Servicebulletin 2026-02

Bulletin Number : PIB-01-2026 Rev. 1

Subject : Vigil Cutter Service Life

Vigil Cutter DOM MM/YY

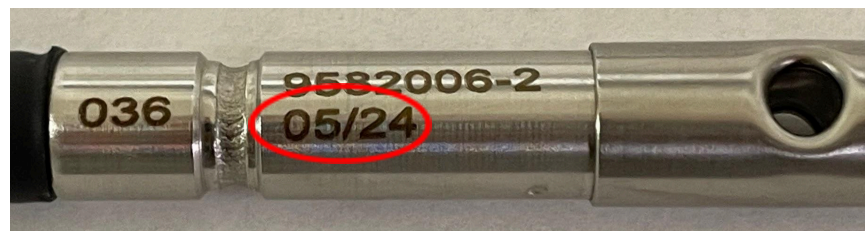
For **Vigil II** AADs, if the DOM of the cutter is more than 6 months prior to the DOM of the Vigil unit, the complete Vigil unit should be sent back to the factory for servicing and or cutter replacement before the end of the service life of the cutter is reached.

For **Vigil 2+** AADs, the cutter may be replaced in the field.

Moving forward, when replacing cutters in the field, to avoid potential situations where the cutter service life of the replacement cutter may exceed the service life of the Vigil unit, it is highly recommended that the replacement cutters not be more than 6 months older than the DOM of the Vigil unit. If older cutters are used, in addition to tracking the DOM of the Vigil unit, the DOM of the cutter must also be tracked to ensure that it does not become unusable because it has reached the end of its expected service life.

For units that have a cutter that is more than 6 months older than the Vigil unit, but are due for battery service prior to the end of the service life of the cutter, the cutter will be replaced at the time battery service is performed.
